# Sleepy Hollow Environmental Advisory Committee Comments on "Edge on Hudson" Phase One Site Plan

before the Planning Board, September 17, 2015. (Amended October 7, 2015)

## Crosswalk Needed at Curve in Road Four

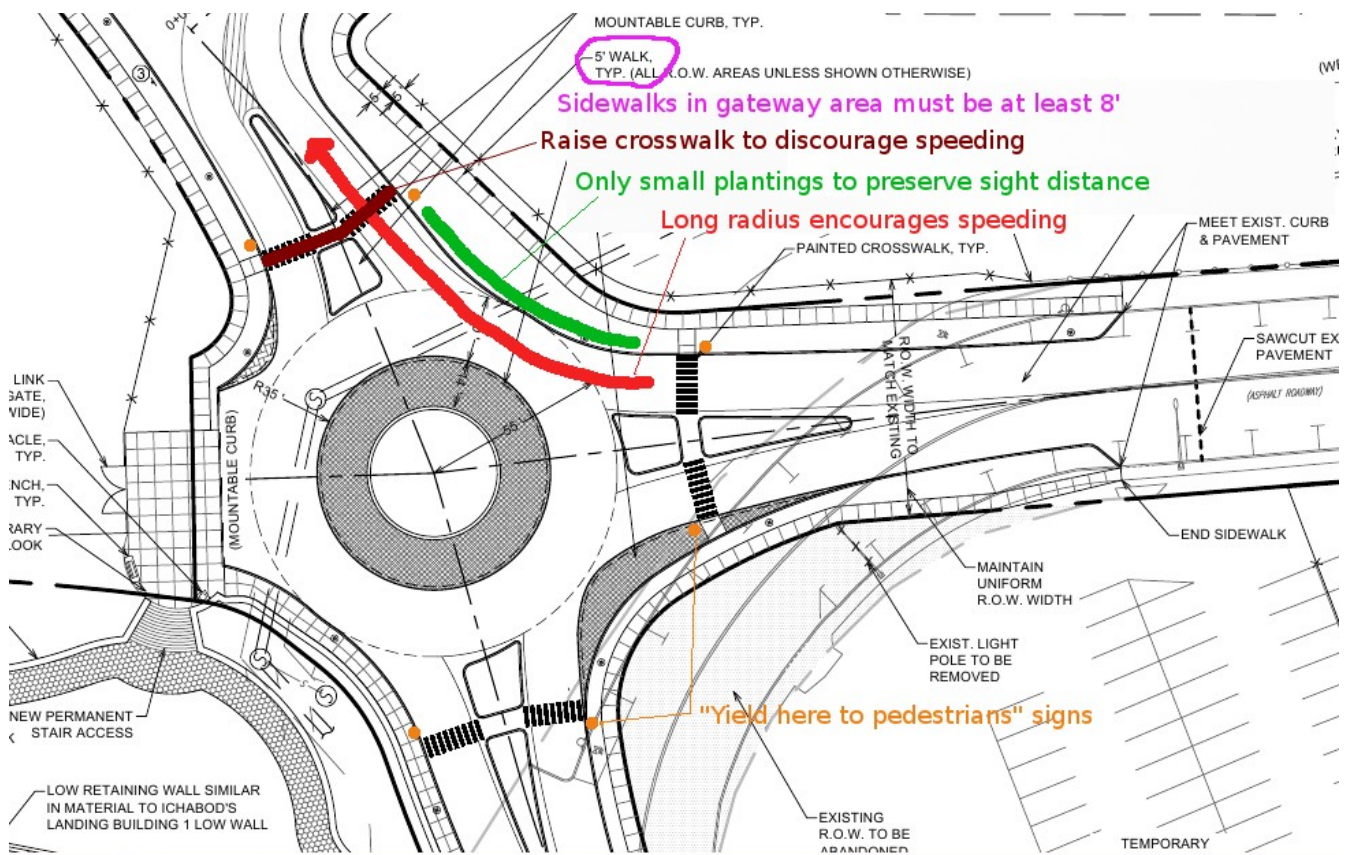
The curve in Road Four at the corner of Building E-2 creates a natural crossing point that pedestrians *will* use. For example, people walking between the southeast end of Central Park and Building I-3 (see purple line in drawing at right). And once the commercial development takes place in Lot 6, people going between it and Building E-1 (see red line). Since the crosswalks will be around a curve, raising the intersection will enhance safety.

The September 3rd drawings add a Plaza at the southeast end of Central Park with decomposed granite ground cover. To ensure a clear, dry, smooth walkway, the hexagonal pavers must be continued through the plaza and connect with Road Four's sidewalk. (See green line in drawing, above.)

## Crosswalk Pavers

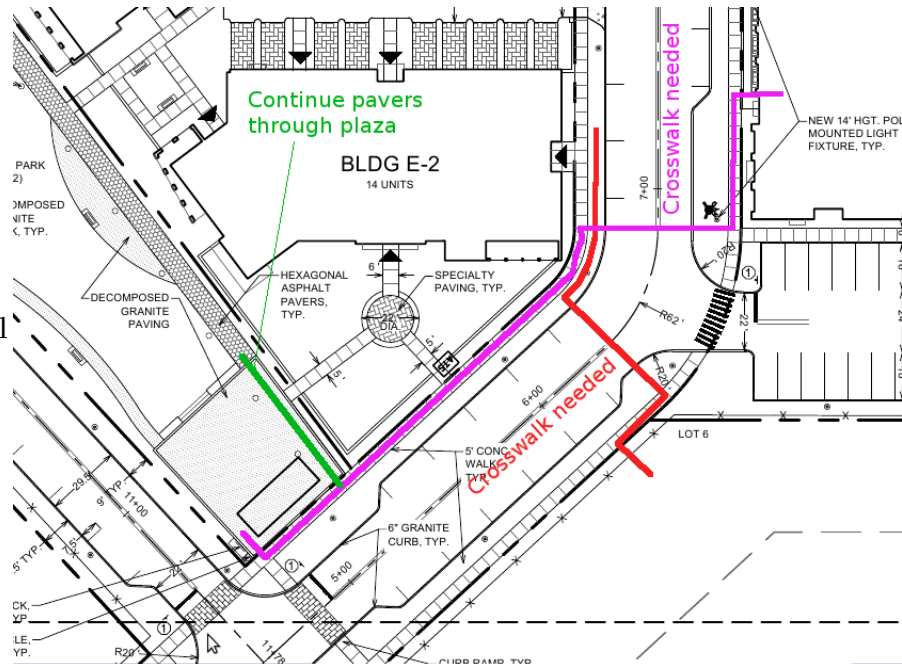
While crosswalk treatments are a nice touch, maintenance is a very large problem with pavers, stone, etc. These systems degrade rapidly, leading to uneven surfaces. Crosswalk treatments should be solid concrete with decorated surfaces.
